Citizens' Oversight Projects (COPs)

August 1, 2012

QUESTIONS FROM CITIZENS OVERSIGHT PROJECTS (COPS) REGARDING STEAM GENERATOR TUBE FAILURES AT SAN ONOFRE NUCLEAR GENERATING STATION

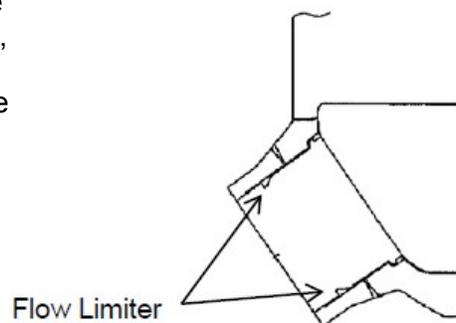
Additionally, Mitsubishi identified that the Unit 3 replacement steam generators had **better dimensional controls during the fabrication process.** This determination was based, in part, on the results of pre-service and in-service eddy current examinations, and fabrication data from Unit 2 and Unit 3 replacement steam generators. The correlation of dimensional controls with the failure mechanism was that improved dimensional controls for Unit 3 replacement steam generators resulted in less variability of as-built critical dimensions such as anti-vibration bar thickness, tube roundness, and gaps between tubes and anti-vibration bars.

It is always assumed that better dimensional control means that the system will perform better. But in terms of fluid-elastic instability, **having tubes with exactly the same natural frequency** will mean that the whole thing will start to vibrate like mad at one key frequency, whereas poor dimensional controls may result in natural frequencies of vibration that are not exactly the same, and thus individual tubes might vibrate, but the additive effect of having many tubes with the same natural frequency may make it **MORE subject to fluid-elastic instability rather than the other way around.**

Q23 ---> Did the team consider that better dimensional control may lead to vibrations that reinforce each other and result in a unstable pole that may lead to catastrophic failure?
